Access Compliance Report

Public Rights-of-Way

(Curb Ramps)

Intersection ID: N/A	Main Street: BURNETTE_AV	Cross Street: VILMA_ST	Location: NW
ADA ID: 2922B8A9DF70	Ramp Type: Perp	Initial Pass/Fail: Fail	Overall Compliance: No
			Severity Score: 33.75

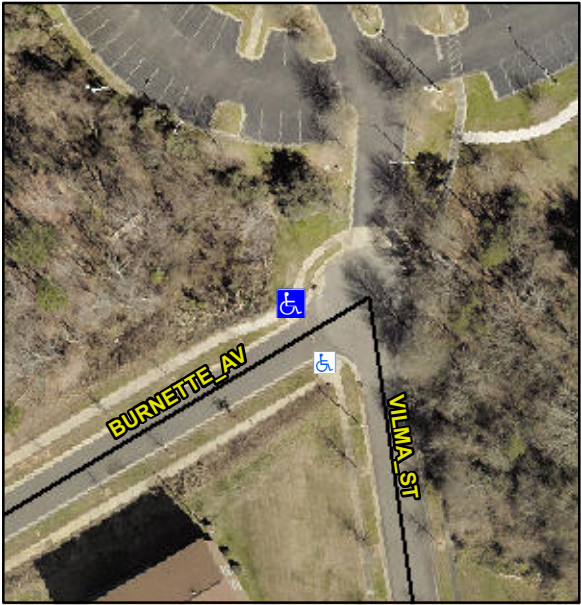
Codes/Mitigation Info/Possible Solution			Field Measurements/Component Compliance		
	Possible Solutions:		Compliance	Description	Data
	Remove & Replace Entire Ramp.		N/A	Ramp Length (in)	47.0
			No	Ramp Width (in)	47.0
			N/A	Flare Type LT	N/A
			N/A	Flare Slope LT (%)	N/A
			N/A	Flare Traversable LT?	N/A
			N/A	Landing Length (in)	N/A
			N/A	Landing Width (in)	N/A
			N/A	Landing Slope (%)	N/A
			N/A	Landing X Slope (%)	N/A
Surveyor Notes: N/A PROW/ADA: Not Found, R304.5.1, R304.2.2, R304.5.3			N/A	Flare Type RT	N/A
			N/A	Flare Slope RT (%)	N/A
			N/A	Flare Traversable RT?	N/A
			N/A	DWS Provided?	N/A
			N/A	DWS Contrast?	N/A
			N/A	DWS Length (in)	N/A
			N/A	DWS Full Width?	N/A
			N/A	DWS Offset (in)	N/A
			N/A	Shared Landing?	N/A
			N/A	Gutter Ponding?	N/A
			N/A	Gutter Lip Ht (in)	N/A
			N/A	Painted X Walk1?	No
				X Walk 1 Direction	To S
			N/A	X Walk 1 Width (in)	N/A
				X Walk 1 Slope (%)	4.8
				X Walk 1 X Slope (%)	5.8
